E3648A-04B**S E R V I C E N O T E**Supersedes:
E3648A-04A**E3648A DC Power Supply****Serial Numbers: MY51240078 to MY99999999****Metal Strap Kit for tightening loose bumper and for fitting rear lock link in side-by-side rack mounting****Parts Required:**

SERVICE NOTE CLASSIFICATION:	
MODIFICATION AVAILABLE	
ACTION CATEGORY:: AGREEABLE TIME	☐ PERFORMANCE ENHANCEMENT ☒ SERVICE / RELIABILITY ENHANCEMENT
LOCATION ☒ CUSTOMER INSTALLABLE CATEGORY: ☐ ON-SITE (active On-site contract required) ☐ SERVICE CENTER ☐ CHANNEL PARTNERS	AVAILABILITY: Until 31 March 2014
☐ Calibration Required ☒ Calibration NOT Required	PRODUCT LINE: WC AUTHOR: TL
ADDITIONAL INFORMATION:

Figure 1: Top view 3mm gap observed between two different chassis designs

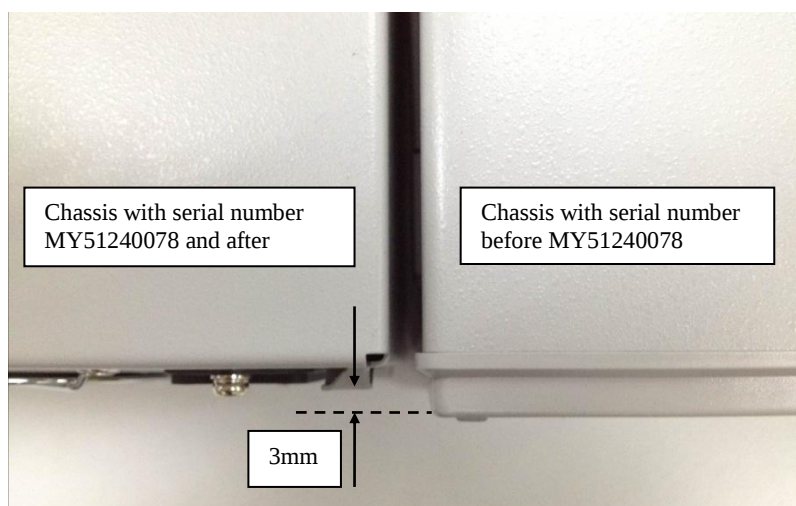
The chassis depth difference between the two designs is 3mm as shown in Table 1 and Figure 1 below.

Serial number range	Chassis depth
MY51240078 and after	345.2 mm
Before MY51240078	348.2 mm

Figure 2: Top view 3mm gap observed on rear lock link for side-by-side rack mounting

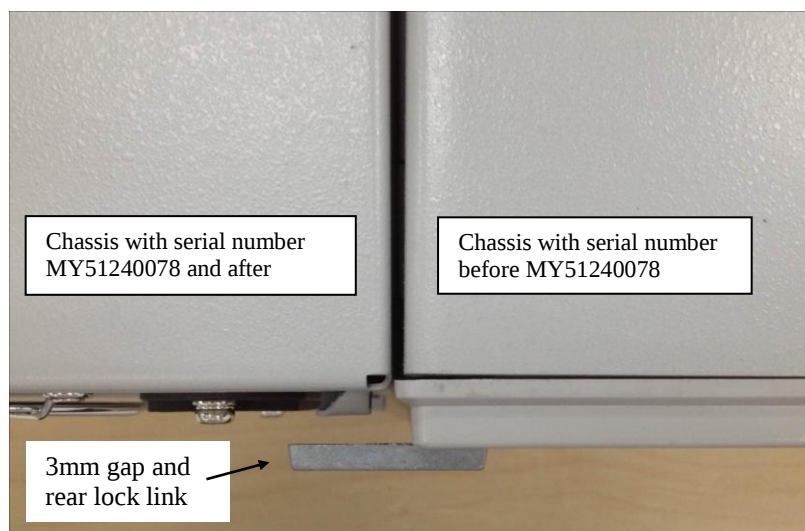
The 3 mm gap between the two different chassis may cause difficulties in securing them together using a rear lock link kit (part number 0050-2167) for side-by-side rack mounting as shown in Figure 2 below.

Use metal strap (part number E3631-07901), and stack the provided two metal straps together to form 3mm thickness and secure it with the provided screws on the rear lock link as shown in Figure 4 below.
